To: Planning and Public Works Committee
From: Justin Wyse, Project Planner
Date: 10/24/2007
RE: **P.Z. 42-2007 Spirit Valley Business Park II (18730 Olive Street Road):** A request for a change of zoning from "NU" Non-Urban District to "PI" Planned Industrial District for a 27.4 acre tract of land located north of Olive Street Road and west of Wardenburg (17W420024).

Petition: P.Z. 42-2007 Spirit Valley Business Park II

RE: P.Z. 42-2007 — Spirit Valley Business Park II (18730 Olive Street Road)

SPIRIT VALLEY BUSINESS PARK II

TYPICAL OLIVE IMPROVEMENT ROAD SECTION
SCALE= NTS

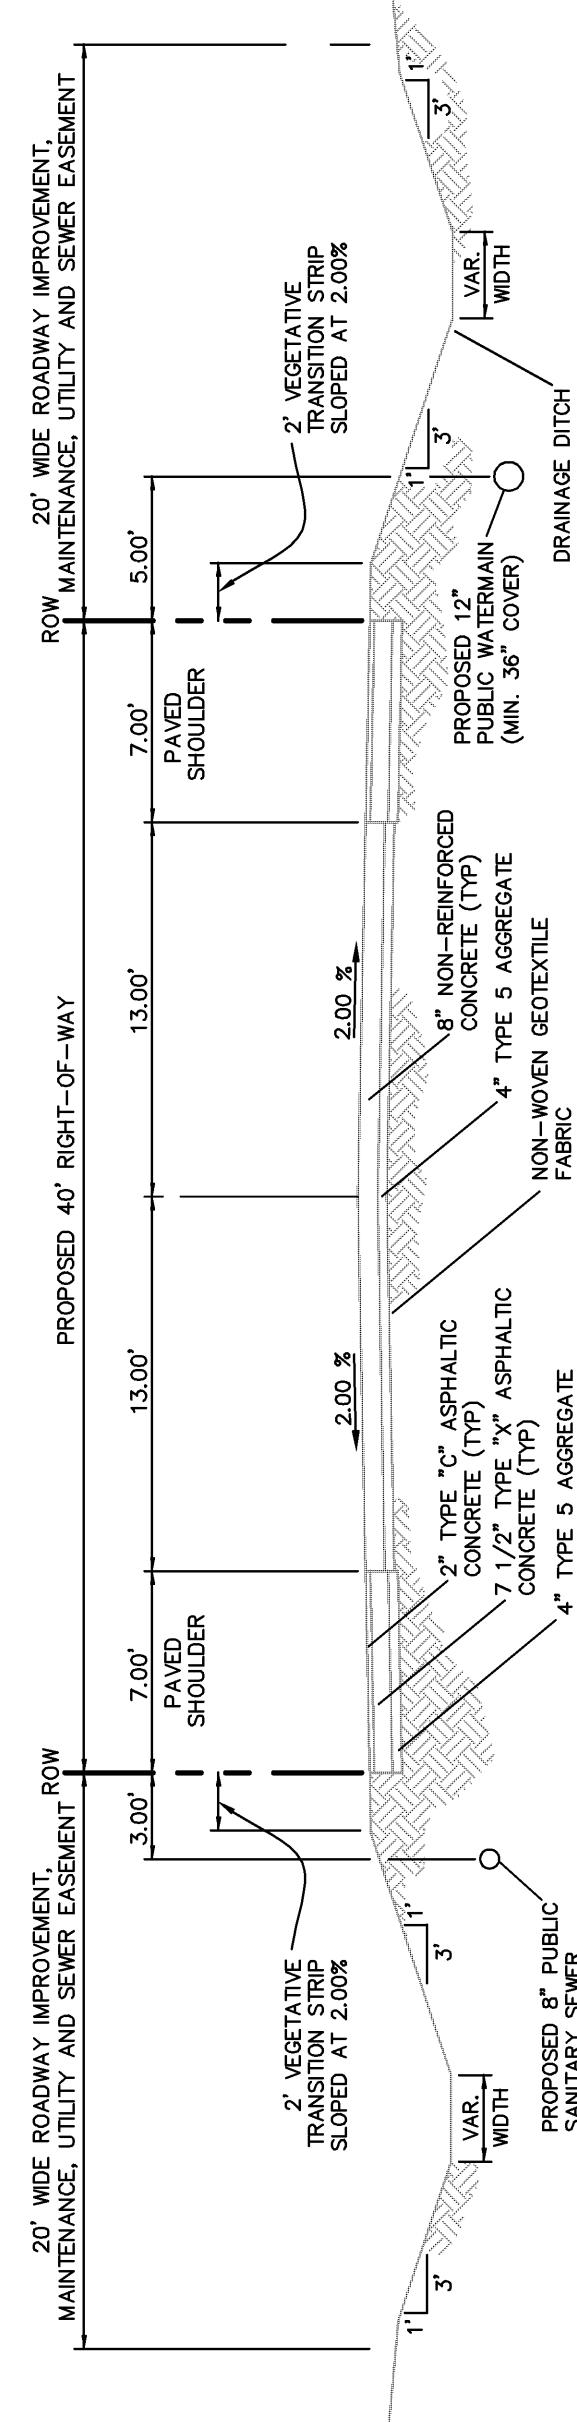
2. Improve Olive Street Road to one-half of a sixty (60) foot right-of-way and a thirty-eight (38) foot pavement with seven (7) foot full depth shoulders and all storm drainage facilities as directed by the Saint Louis County Department of Highways and Traffic.

Response: We acknowledge this requirement.
